CERTIFICATE OF APPROPRIATENESS

Proposal: Alteration – Replace existing non-original Texas Street entry doors and alter 110 window openings on floors 3-16.

ITEM B.20

909 Texas Street (518 Main Street)
Main Street Market Square
Landmark: Rice Hotel

3D RENDERING – FRONT FACING TEXAS STREET
PROPOSED

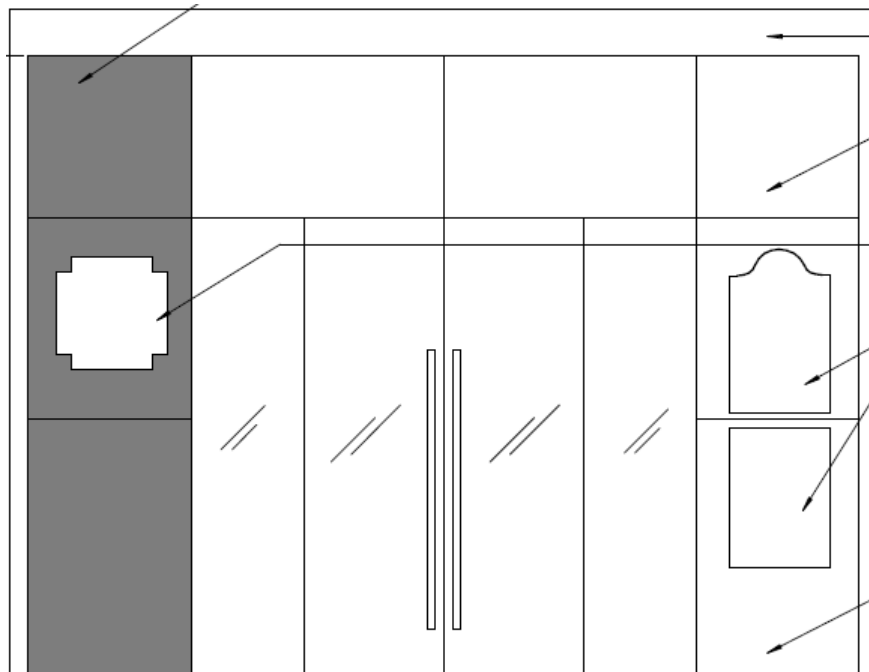
<i>The primary entrance into the building is a significant aspect of its character, and the proposed alterations create a contemporary entry that is not in keeping with the building's historical character.</i> | |

<i>The relationship of solids to voids in the ground level storefronts creates a rhythm that ties the blockface together and links the building to the rest of the district. The proposed entry, with its large expanse of frameless glass and exaggerated marble surround, disrupts that rhythm.</i> | |

<i>Though the individual materials themselves may be appropriate, an unbroken expanse of glass for the Texas Street entry uses the material at a scale incompatible with its use elsewhere on the structure.</i> | |

<i>Though the existing entry doors are not original, they are of an appropriate character for this building. A frameless glass entry is not appropriate.</i> | |

Recommendation: Partial Approval: Approval of window alterations; Denial of alterations to Texas Street entry

HAHC Action: Partially Approved: Approval of window alterations; Denial of alterations to Texas Street entry
